123 SHERMAN AVENUE PALO ALTO, CA

ARB AD HOC COMMITTEE MEETING PRESENTATION

09/22/2023

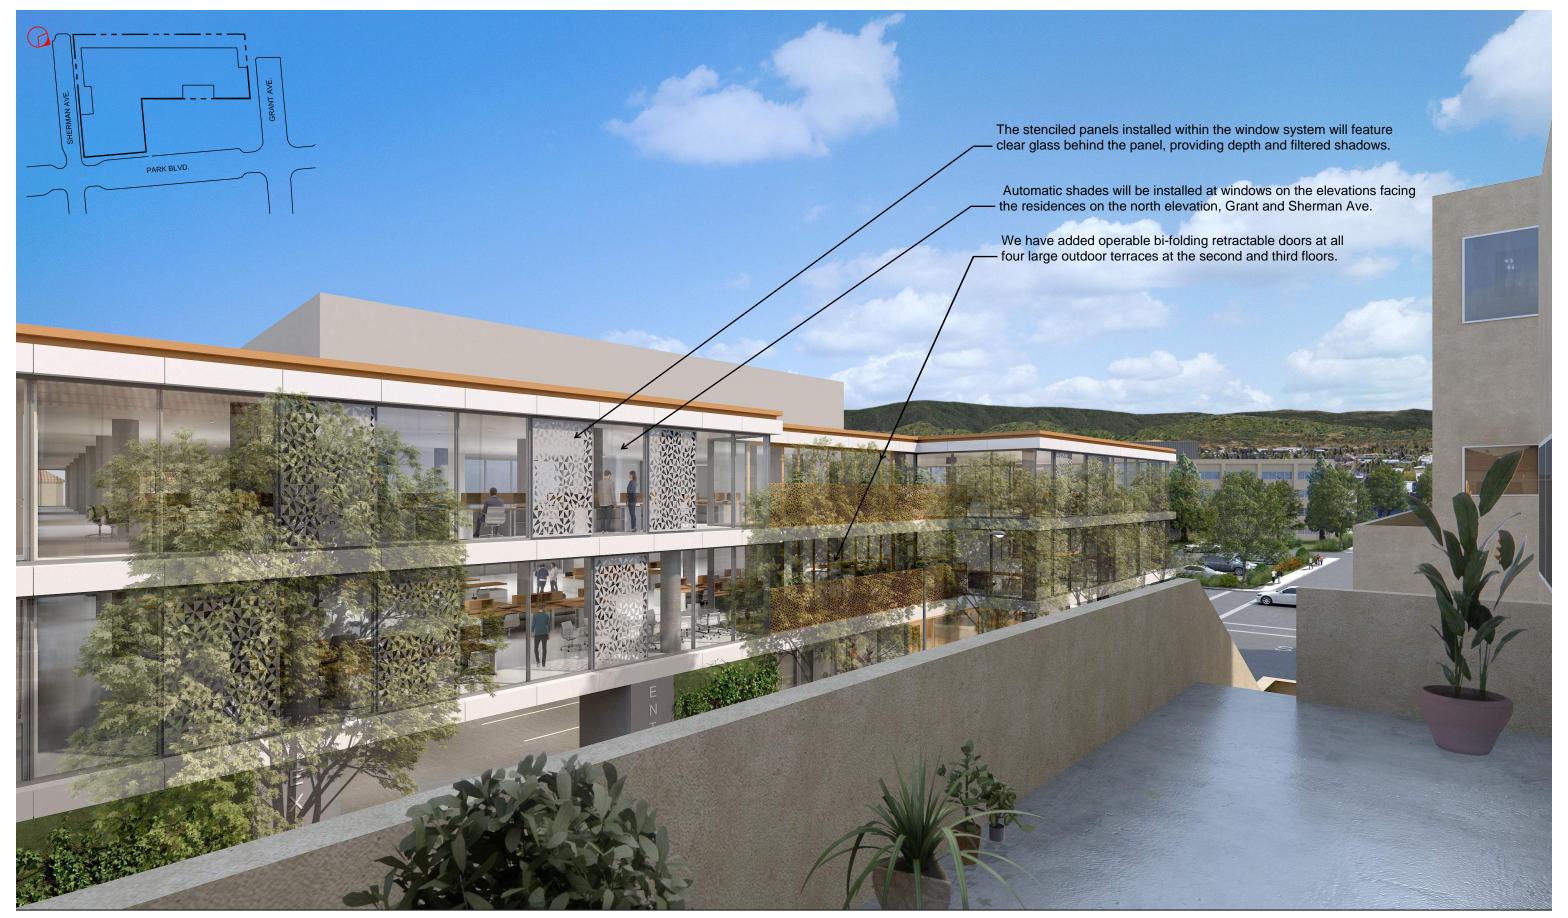
In addition we would like to also remove the rooftop mechanical enclosure facing Park Boulevard

One of the neighbors who lives on Sherman Avenue across the street from the 123 Sherman project has asked if it would be possible to lesson the impact on her view over the building by reducing the size of the mechanical enclosures on the roof of the building.

Response: The design approved by the ARB included a 5' tall rooftop mechanical screen along Park Boulevard. After further review of the mechanical system it has been determined that no mechanical equipment will be required in this location. Smith Development would like to remove this screen from the project.

Study feasibility of café use

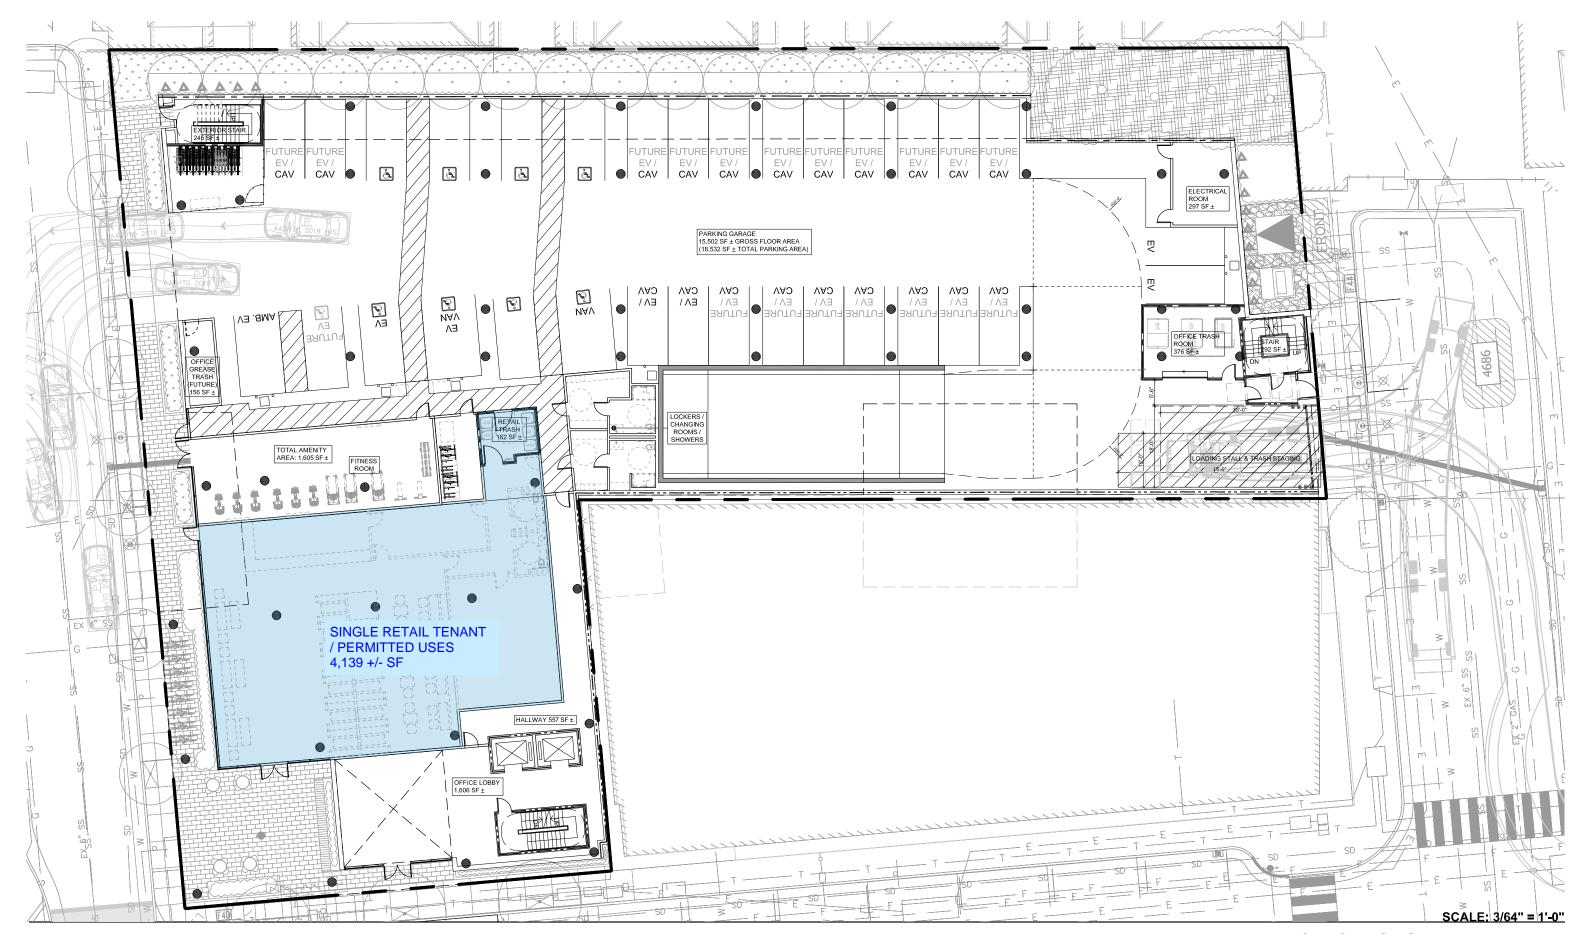
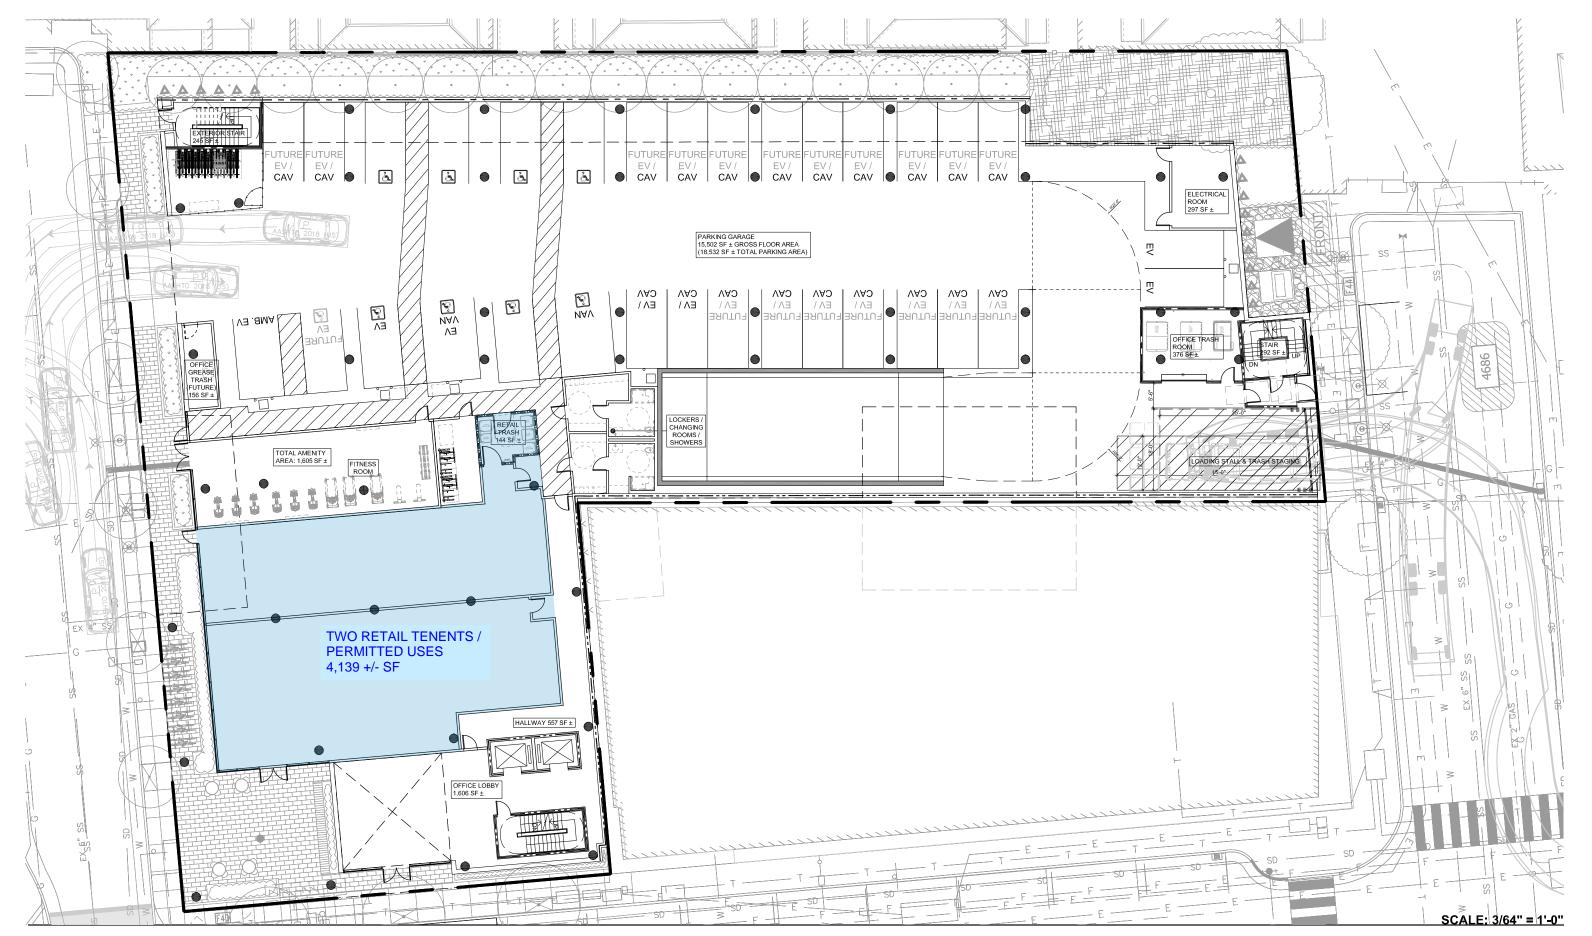
a. Study feasibility of cafe use

Response: Commercial brokers have reviewed the project and have concluded that the proposed space provided for a cafe use is appropriate. The space can work for a single tenant or for two tenants. Please refer to page 11 for the layout for a single tenant and page 12 for the layout for two ground floor tenants.

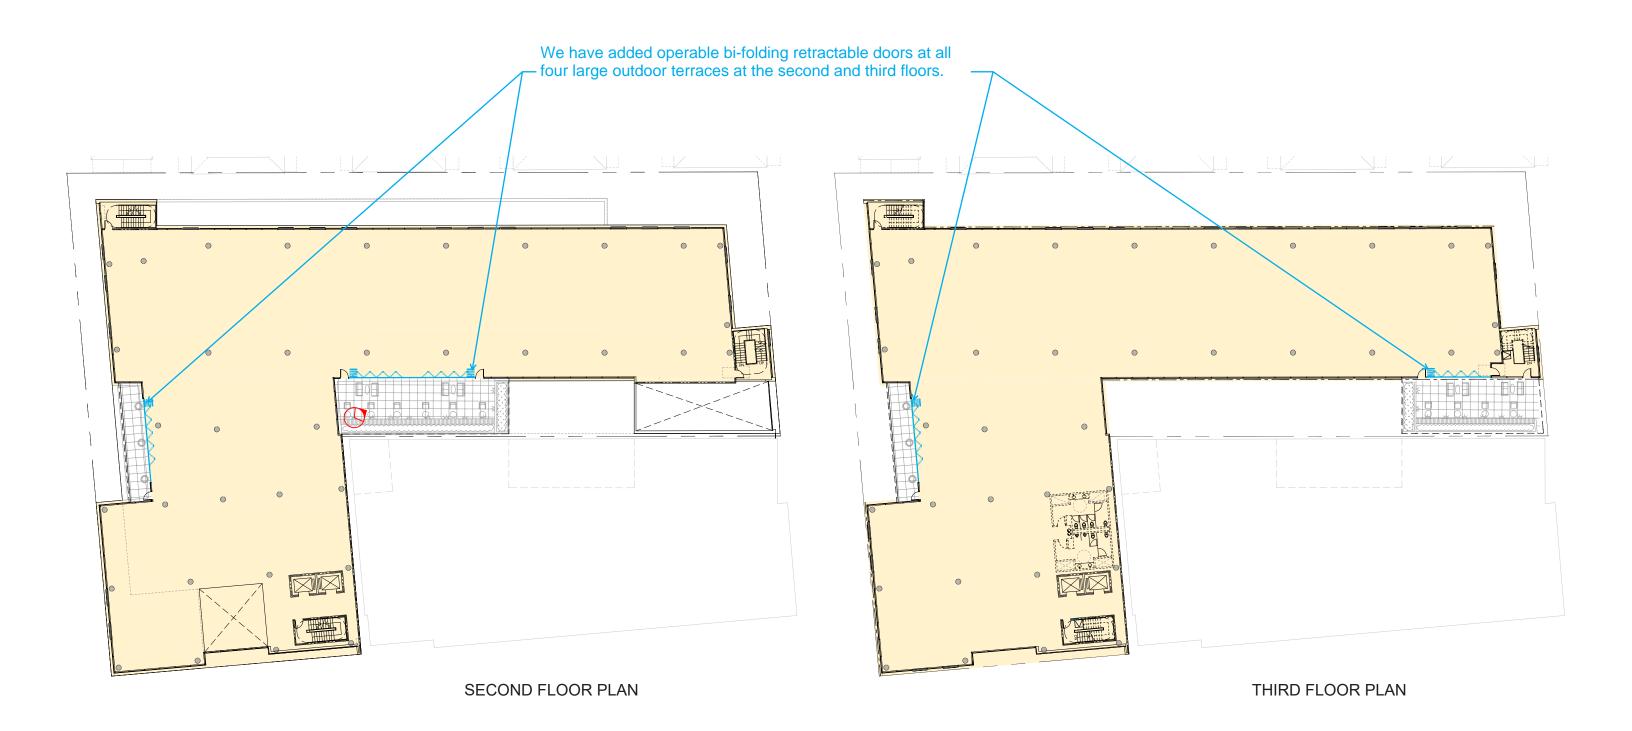
b. Study feasibility of adding operable windows

Response: We have added operable bi-folding retractable doors at all four large outdoor terraces at the second and third floors. This will allow the occupants of the building to enjoy natural ventilation and create an expansive indoor/outdoor experience b.

c. Add additional screens to windows (with glass)

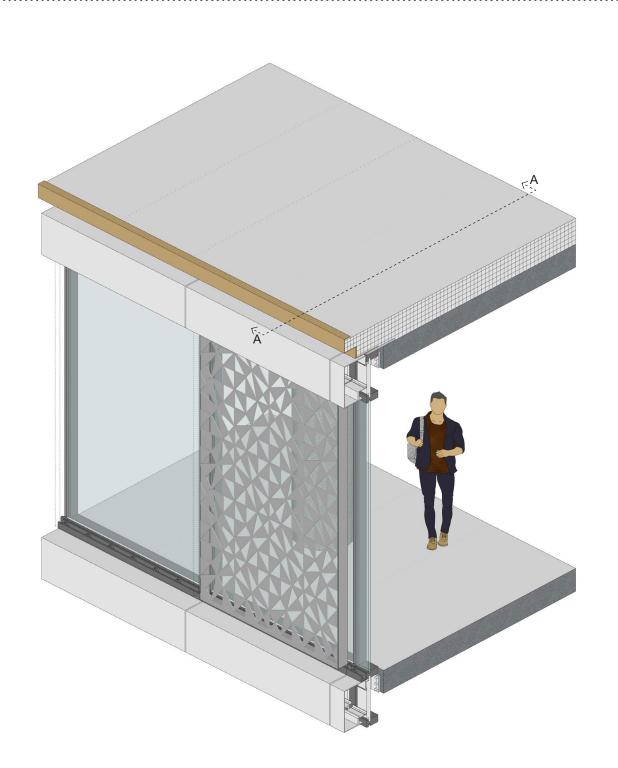
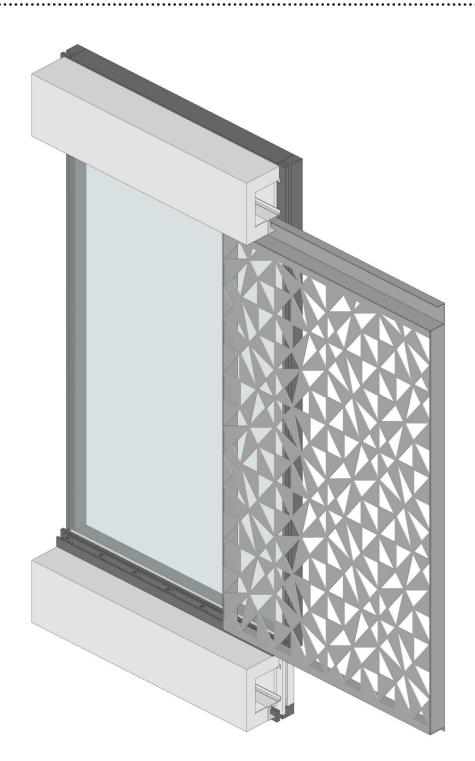
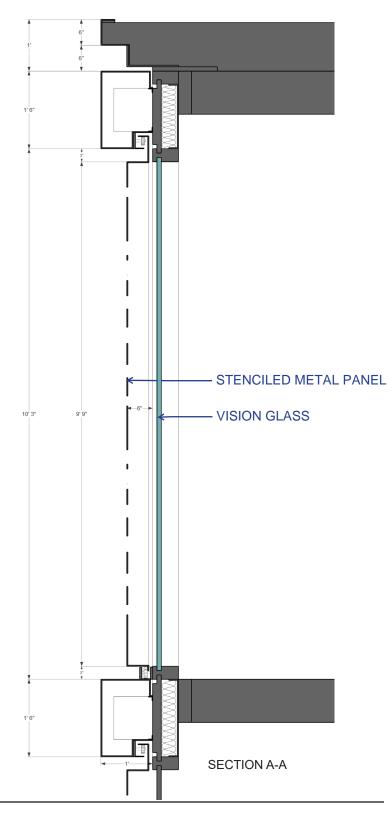
c. Add additional screens to windows (with glass)

Response: The stenciled panels installed within the window system will feature clear glass behind the panel, providing C. depth and filtered shadows. Please refer to pages 15, 16, 18, 20 and 23

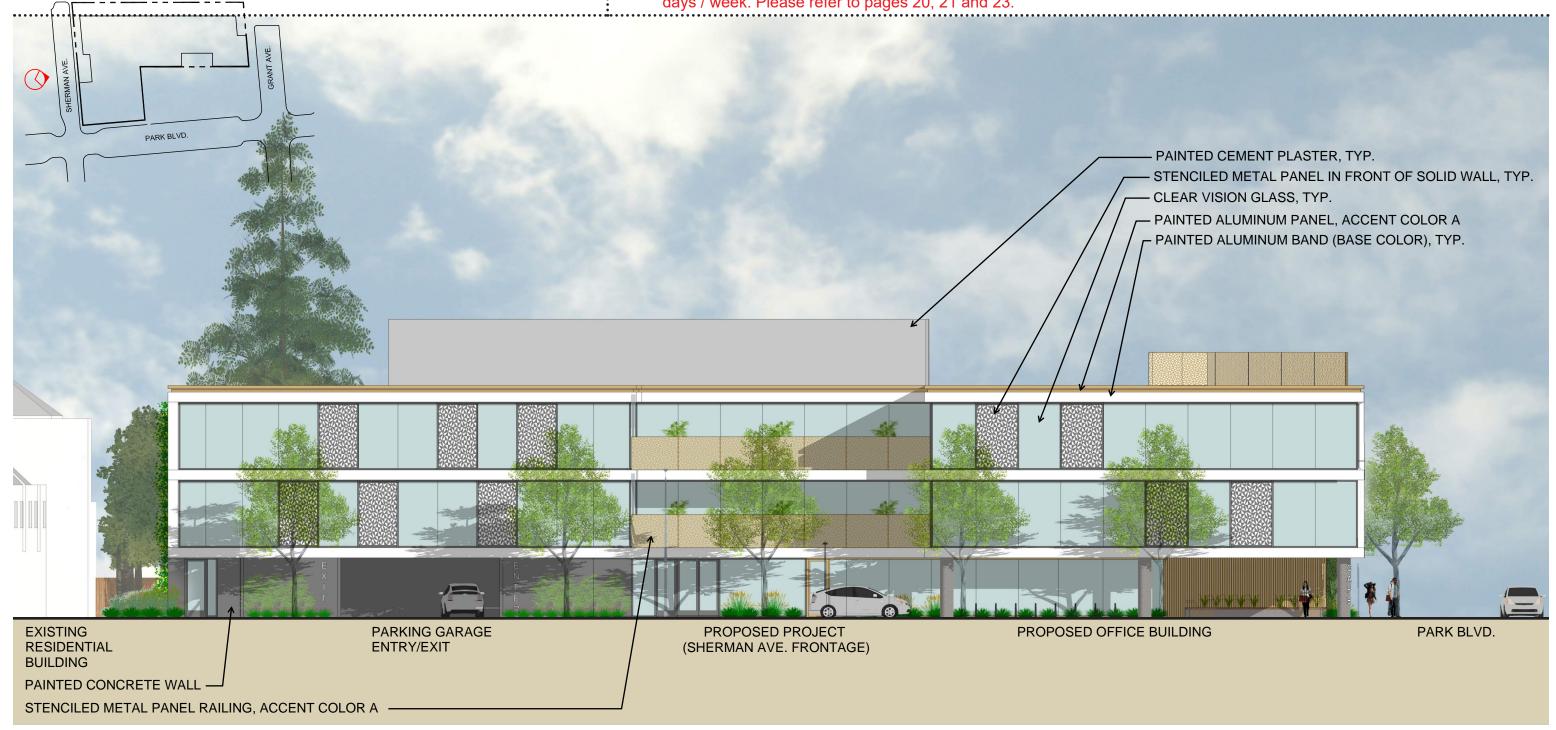
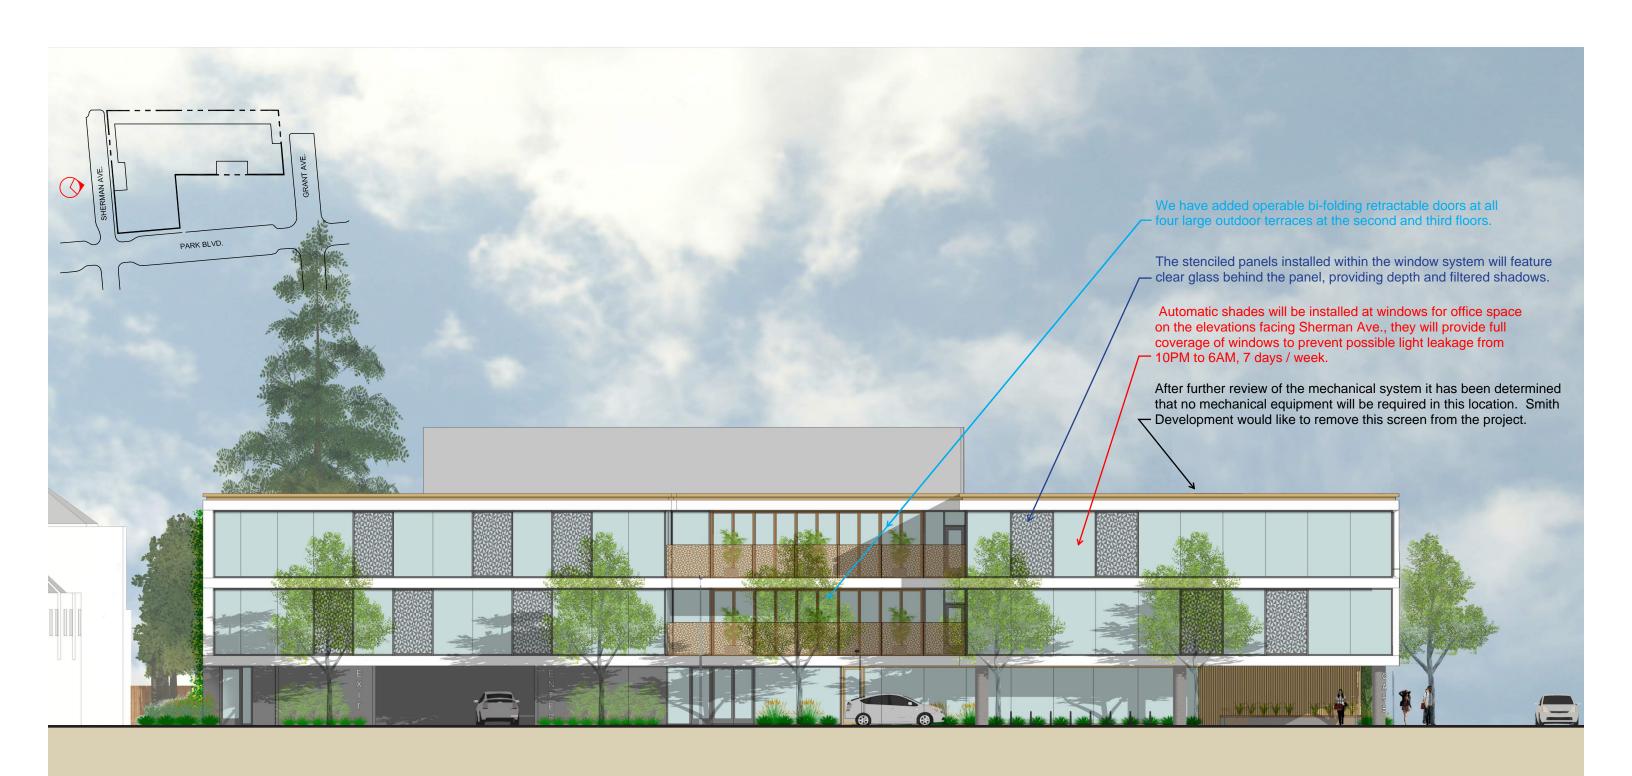
- Study feasibility of adding operable windows
- Add additional screens to windows (with glass)
- Add automatic shades to the windows, on sides facing residences

- Response: We have added operable bi-folding retractable doors at all four large outdoor terraces at the second and third floors. b. This will allow the occupants of the building to enjoy natural ventilation and create an expansive indoor/outdoor experience adjacent to the outdoor terraces. Please refer to pages 13,14 and 20
 - Response: All of the stenciled panels installed within the window system will feature clear glass behind the panel, providing depth and filtered shadows. Please refer to pages 15, 16, 18, 20, 21 and 23
 - Response: Automatic shades will be installed at windows on the elevations facing the residences on the north elevation, Grant and Sherman Ave. They will provide full coverage of windows to prevent possible light leakage from 10PM to 6AM, 7 days / week. Please refer to pages 20, 21 and 23.

Add automatic shades to the windows, on sides facing residences

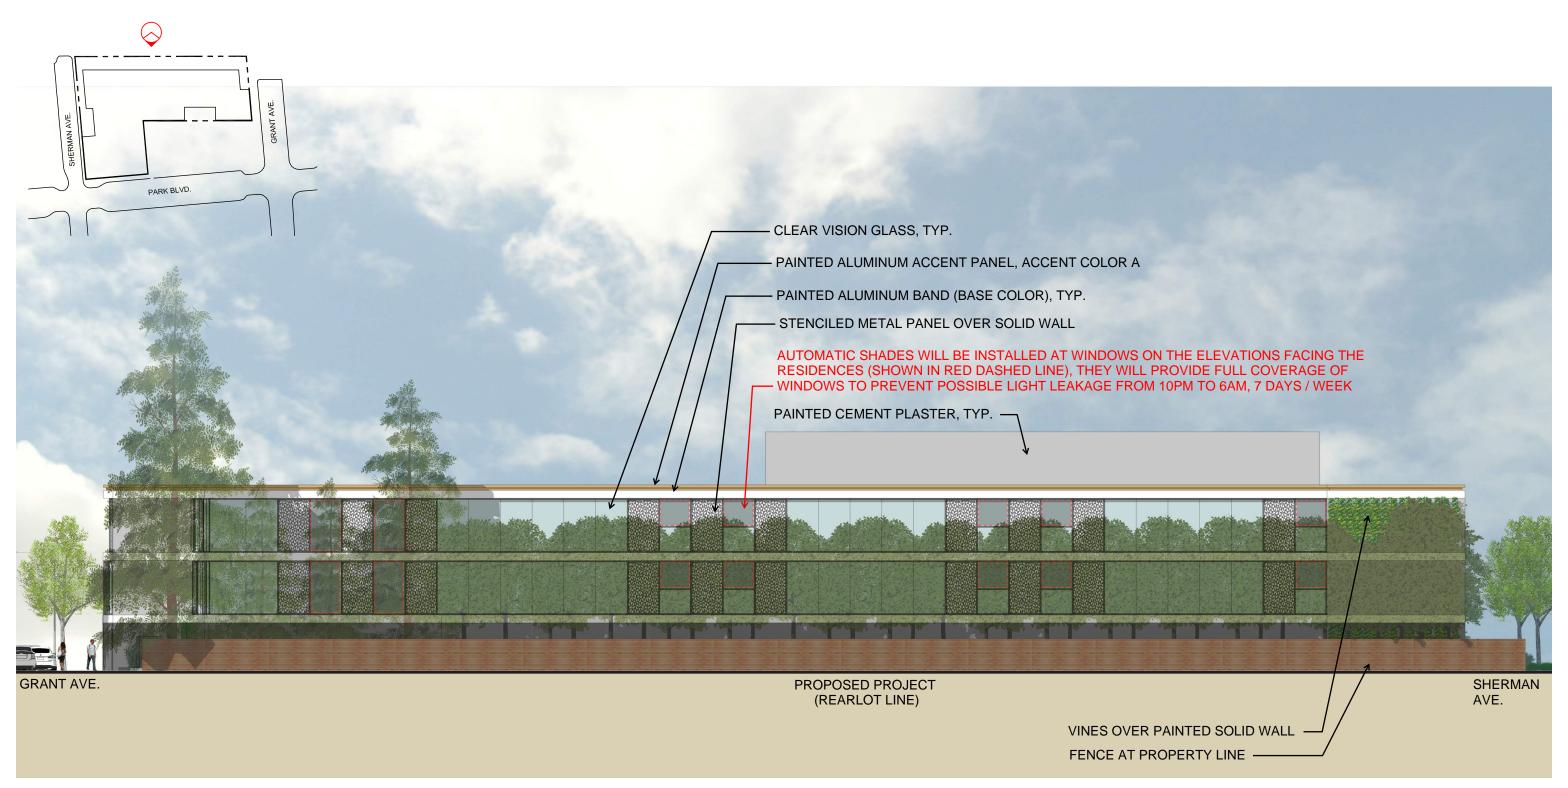
d. Add automatic shades to the windows, on sides facing residences

Response: Automatic shades will be installed at windows on the elevations facing the residences on the north elevation, d. Grant and Sherman Ave. They will provide full coverage of windows to prevent possible light leakage from 10PM to 6AM, 7 days / week. Please refer to pages 20, 21 and 23.
